**2446 SOUTH COAST HWY, DENMARK**  
**Local Development Plan**

**SCHEDULE OF SUBMISSIONS: LOCAL DEVELOPMENT PLAN – LOT 3 SOUTH COAST HIGHWAY, WILLIAM BAY (A541)**

## Schedule of Modifications – Local Development Plan Lot 3 (No. 2446) South Coast Highway, William Bay

SHEET 1 OF 2	FILE
DRAWING No.	A
AE 0025-5	3
04/09/2025

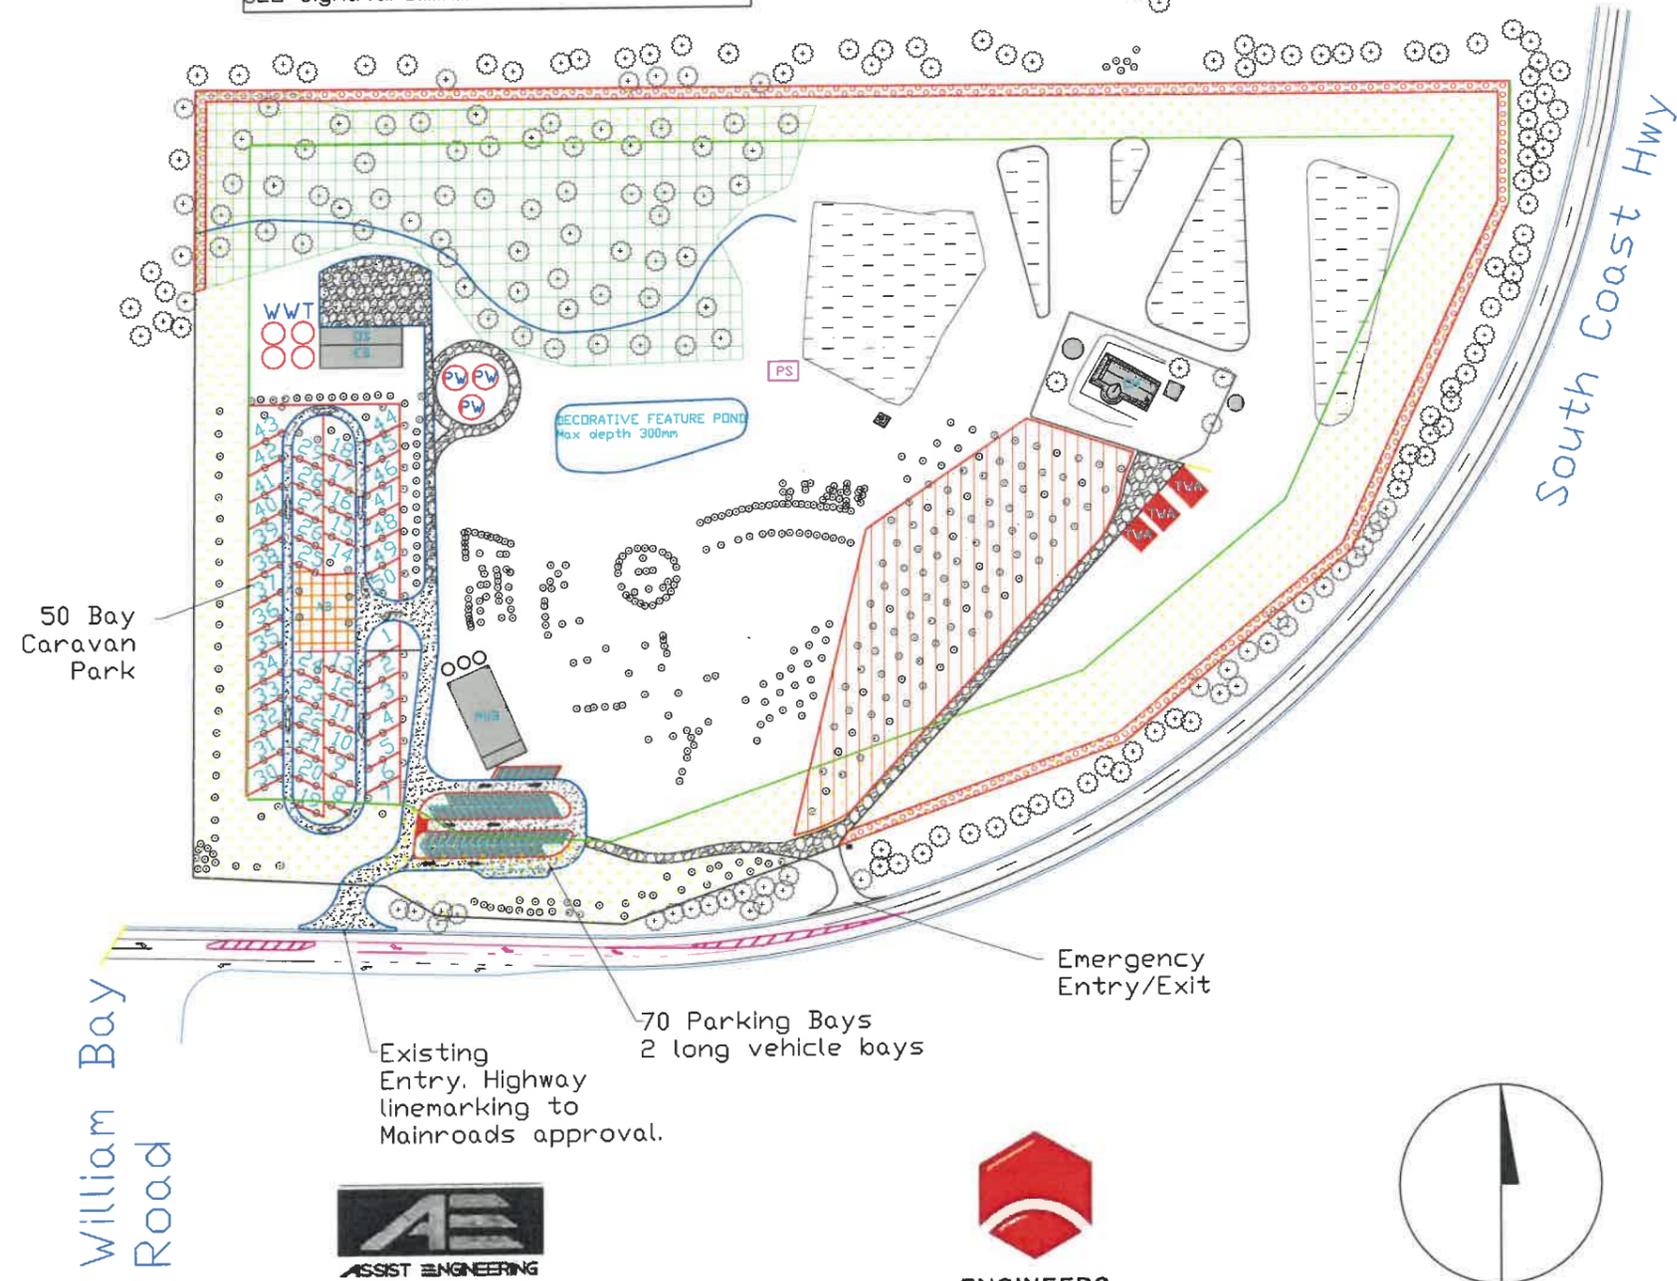
How can one submit a LDP for approval knowing the development will only “be generally in accordance with the LDP”? How am I expected to comment on this if there will be changes? This proposal is not ready for comment.

According to the Draft LDP Map provided, the existing vegetation screening South Coast Highway is on road reserve and therefore not part of the development. The supplemented additional planting is not shown on the map and the Shire requirements have not been provided. The existing vegetation shown to the north of their boundary is actually on The Wolery, and so cannot be shown as being part of this development. Being a neighbour with a common boundary on the north of this development, I would need to see in writing a requirement/condition by the Shire, and a commitment by the proponent/s, to screen this development from our property before I would consider approving this development.

Currently there is no approval for a Secondary Treatment Plant.

Mapping of the caravan park section  
In contrast to the original caravan park area that was much closer to the Western boundary, the new map shows it fitting neatly 20 mtrs from the Western boundary and 30mtrs from the Main Road boundary.  
The drone picture appended below seems to indicate that the proposed caravan bays are only 15mtrs from the Western boundary and less than 30mtrs from the Main Roads boundary. Our drawing of caravan sites based on the on-ground markings as seen from above may give a more truthful picture.

Compared to the original proposal, which placed the caravan park area much closer to the western boundary, the new map shows it positioned 20 metres from the western boundary and 30 metres from the Main Road boundary. Yet no change has been made to the plantings which outline proposed sites. I trust that the Shire will investigate these distances before approval.

M4	Western rural interface	Require a minimum 20m planted buffer along the western boundary. The buffer is to be designed, established and maintained through the LDP Landscape Plan (species/densities; screening function). Include advice that the effective vegetated depth may be increased at DA if testing warrants.	Manage amenity and spray drift at the rural interface.
M5	Built form & screening	Retain single-storey height, recessive/non-reflective materials and setbacks. Tie these controls to a binding Landscape Plan that delivers perimeter screening (including the highway frontage) on-site (i.e., not relying on road reserve vegetation).	Visual landscape outcomes; clarity that screening occurs on-site.
M6	Tree Retention / Development Exclusion Area	Add a specific requirement in the Landscape Plan to preserve and enhance identified Tree Retention / Development Exclusion Areas and to rehabilitate any disturbed sections.	Respond to submissions and prior EPA advice; maintain internal vegetation values.

**2446 SOUTH COAST HWY, DENMARK**  
**Local Development Plan**  
**Mainroads Right Turn Pocket**

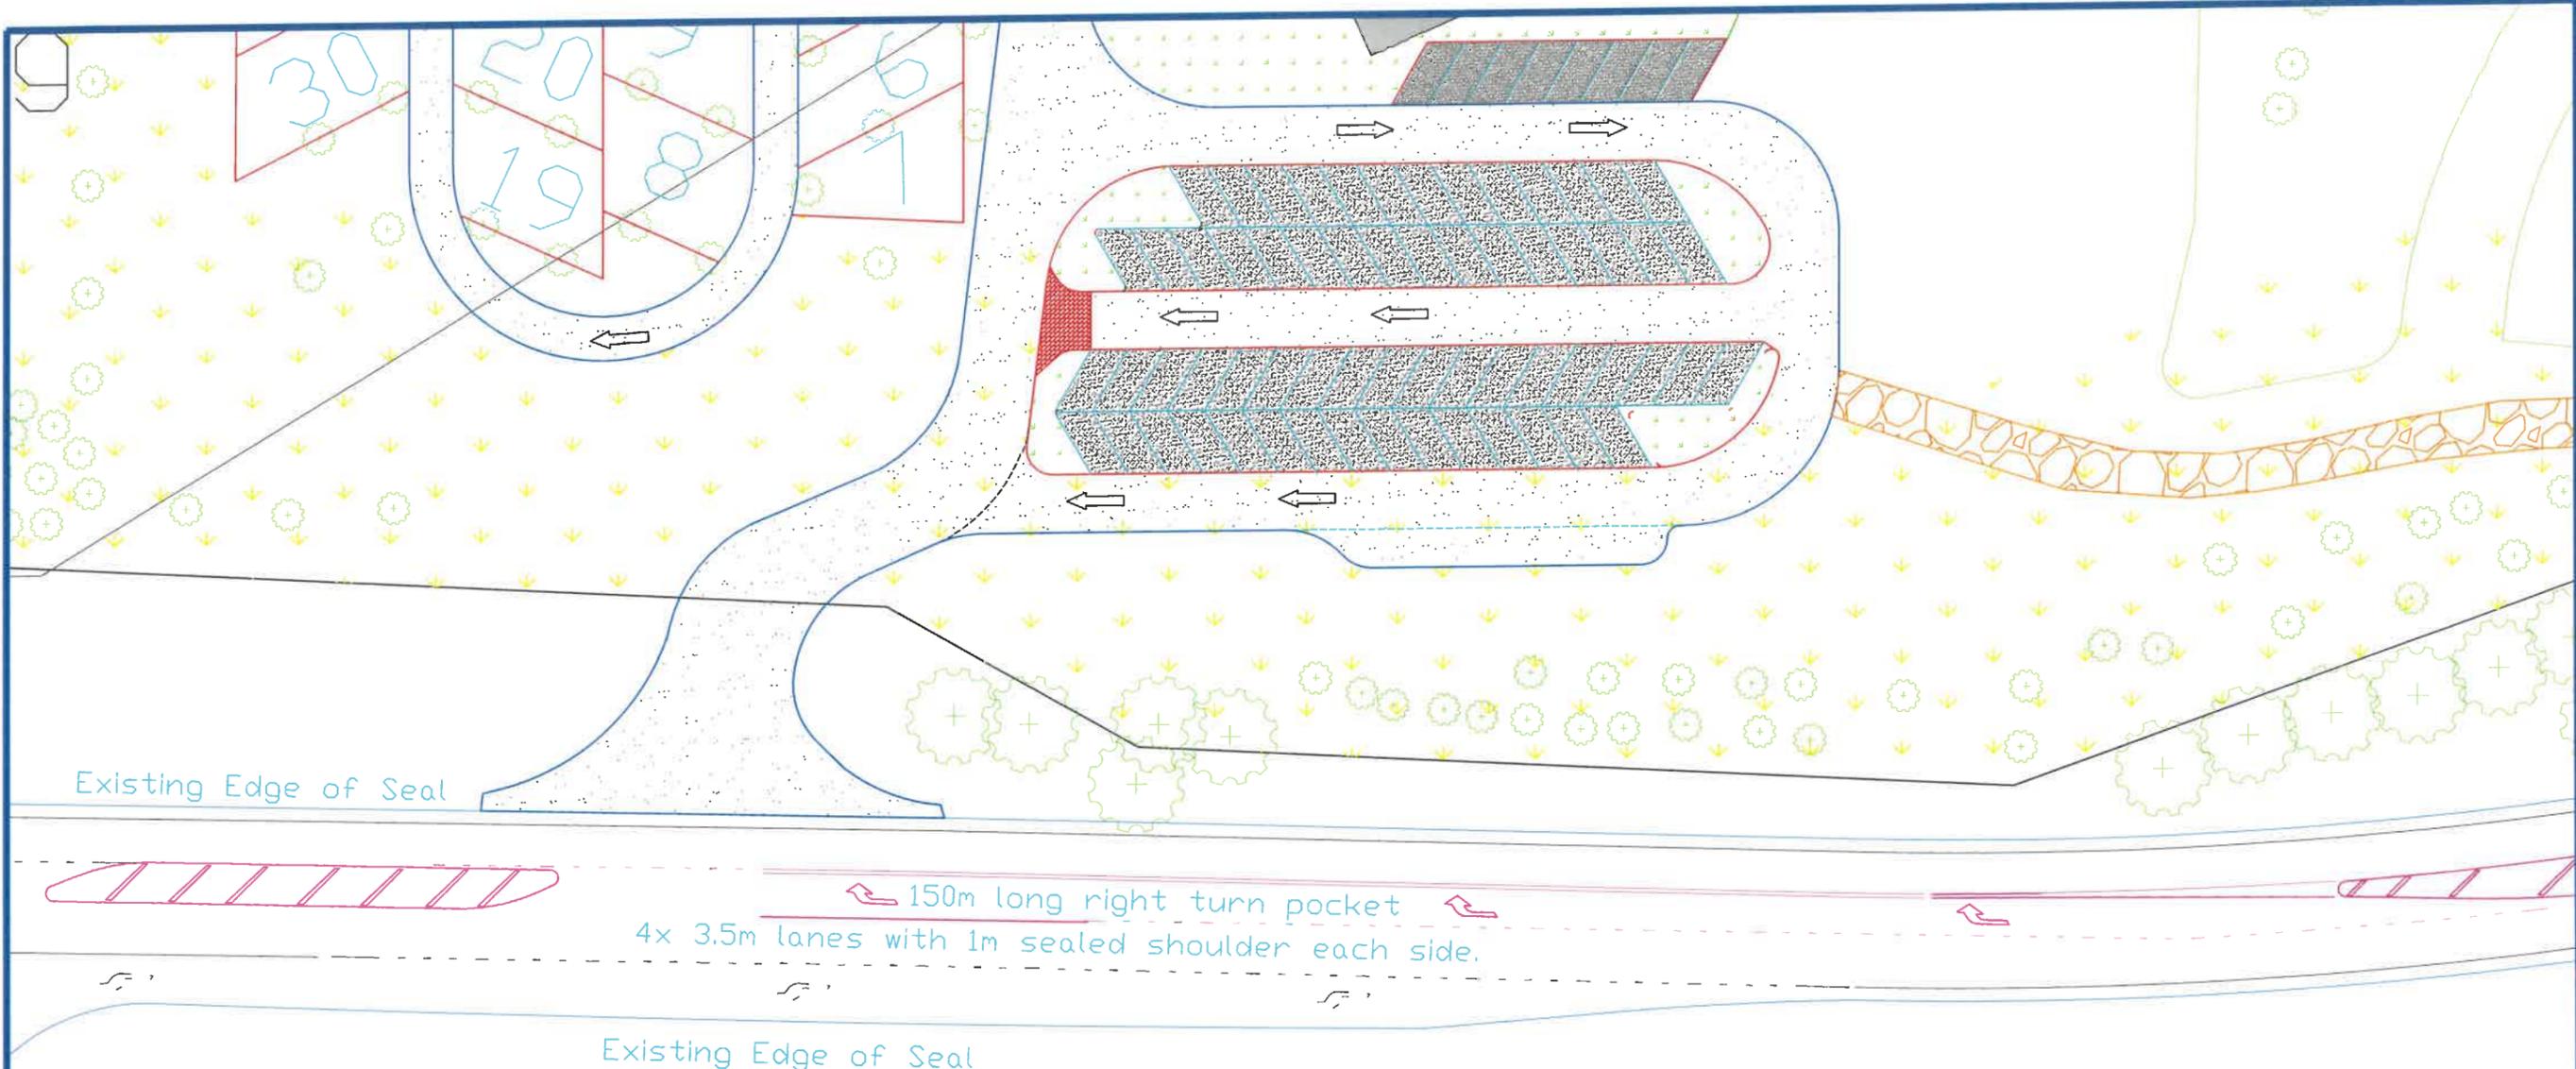
The Main Road entry to Lot 3 and drafted alterations to the existing road. It has been our considered opinion that the addition of the new entry will create a black spot for road safety. The drafted suggestion of how that entry may work has added to our concerns. The overtaking lane will be shortened (There have already been three serious crashes where the overtaking lane ends). The altering of the existing overtaking lane start at the Greens Pool turn-off to becoming a right hand turn into Lot 3 will exacerbate a very confusing intersection. Cars already use this overtaking lane to avoid slow turning traffic from the Greens Pool Rd. due to the poor site lines to the West, cars approaching have minimal time to assess what is happening at Greens Pool. With the new road layout suggestion these cars would have nowhere to go except head-on into a right turning vehicle. The large volume of traffic turning out of Greens Pool Road will now have to assess right turning traffic into Lot 3, left turning traffic into Greens Pool and through traffic heading to Walpole whilst also assessing the impact to their manoeuvre of traffic entering and leaving Lot 3.

<b>Government Agency Submissions</b>			
G1	<p>██████████  Main Roads Great Southern  <a href="mailto:gsreg@mainroads.wa.gov.au">gsreg@mainroads.wa.gov.au</a></p>	<p>Original Advice  Main Roads does not support the Draft LDP - 2446 South Coast Highway, Denmark Local Development Plan AE 0025-5 Sheets 1 and 2.</p> <p>Updated advice, offering further explanation:</p> <p>The previous response indicates Main Roads lack of support of the Draft LDP - 2446 South Coast Highway, Denmark Local Development Plan AE 0025-5 Sheets 1 and 2 to utilise the existing Eastbound overtaking/acceleration lane on South Western Highway and convert a section of it into a right turn pocket to service this development. Main Roads considers the predominant traffic need in this vicinity is for the existing over taking opportunity/acceleration lane Eastbound from the William Bay Rd Intersection to remain fully functional. Plans to locate it to further to the East to accommodate access into this development is not supported as it would negatively impact the Eastbound traffic movements on the steep grade of the South Western Highway immediately East of the William Bay Rd intersection. The relocation of</p>	<ul style="list-style-type: none"> <li>• Main Roads' advice is noted. MRWA has assessed the proponent's Traffic Impact Statement and also applied its own network and safety criteria for this high-speed, uphill eastbound section—hence its position to retain the current eastbound overtaking/acceleration lane and not convert/relocate it to form a right-turn pocket.</li> <li>• To avoid implying or pre-judging any highway works, the LDP will delete any figure/note that depicts, relies upon, or commits to changes to South Coast Highway (including a right-turn pocket or relocation of the overtaking lane). The LDP will instead include the following neutral note: "Any works within South Coast Highway are subject to separate MRWA approval; this LDP does not approve or imply any highway works."</li> <li>• MRWA's support for the relocated crossover is acknowledged as per the TIS. Any legacy reference to the original access will be removed from current mapping/documents so only the current crossover</li> </ul>

Ref.	LDP Element	Modification (to be shown on LDP plan/text)	Reason / Source
M1	Highway interface / notes	Delete all figures/notes that depict or commit to highway works (e.g. right-turn pocket, repurposed/relocated overtaking lane). Insert a single standard note: "Any works within South Coast Highway are subject to separate MRWA approval; this LDP does not approve or imply any highway works."	Consistency with MRWA advice and LDP scope; on-site outcomes only.
M2	Access mapping	Remove any legacy reference to the original crossover. Show only the current, MRWA-supported crossover location.	Housekeeping per MRWA updated advice.
M3	Parking	Replace the fixed number of parking bays with a performance-based control: "Car parking (including long-vehicle bays) to be confirmed to the Shire's satisfaction at Development Application stage, having regard to final land-use mix and staging."	Flexibility to size parking to the final use mix.
